Access Compliance Report

(Curb Ramps)

Intersection ID: 49927	Main Street: ASHBOURNE_HALL_RD	Cross Street: CAMPBELL_HALL_CT	Location: SW
ADA ID: 05C19343EE1A	Ramp Type: Perp	Initial Pass/Fail: Fail	Overall Compliance: No
Severity Score: 13.75			
Codes/Mitigation Info/Possible Solution		Field Measurements/Component Compliance

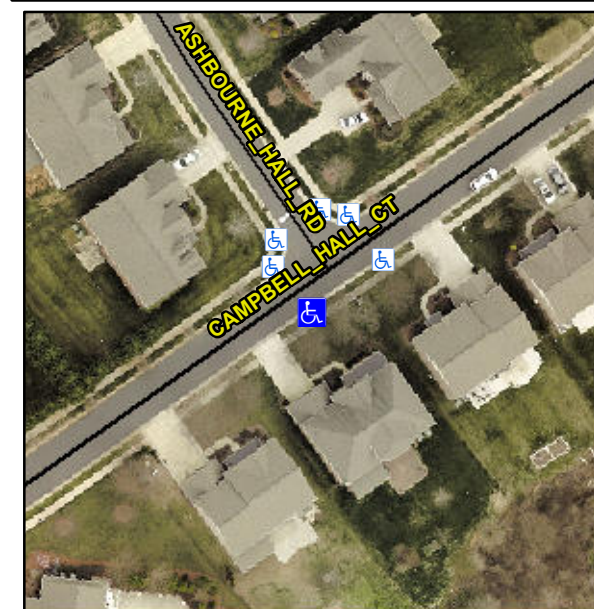
R304.2.2, R304.5.3

Compliance	Description	Data	Compliance	Description	Data
N/A	Ramp Length (in)	48.0	No	Ramp Slope (%)	10.2
Yes	Ramp Width (in)	48.0	No	Ramp XSlope (%)	2.8
N/A	Flare Type LT	N/A	N/A	Flare Type RT	N/A
N/A	Flare Slope LT (%)	N/A	N/A	Flare Slope RT (%)	N/A
N/A	Flare Traversable LT?	N/A	N/A	Flare Traversable RT?	N/A
N/A	Landing Length (in)	N/A	N/A	DWS Provided?	N/A
N/A	Landing Width (in)	N/A	N/A	DWS Contrast?	N/A
N/A	Landing Slope (%)	N/A	N/A	DWS Length (in)	N/A
N/A	Landing X Slope (%)	N/A	N/A	DWS Full Width?	N/A
N/A	Landing Curb? (Y/N)	N/A	N/A	DWS Offset (in)	N/A
N/A	Shared Landing?	N/A			
N/A	Gutter Ponding?	N/A	N/A	Gutter Slope (%)	N/A
N/A	Gutter Lip Ht (in)	N/A	N/A	Gutter X Slope (%)	N/A
N/A	Painted X Walk1?	No	N/A	Painted X Walk2?	N/A
	X Walk 1 Direction	To NW		X Walk 2 Direction	N/A
N/A	X Walk 1 Width (in)	N/A	N/A	X Walk 2 Width (in)	N/A
	X Walk 1 Slope (%)	2.2		X Walk 2 Slope (%)	N/A
	X Walk 1 X Slope (%)	1.9		X Walk 2 X Slope (%)	N/A

Remove & Replace Entire Ramp.
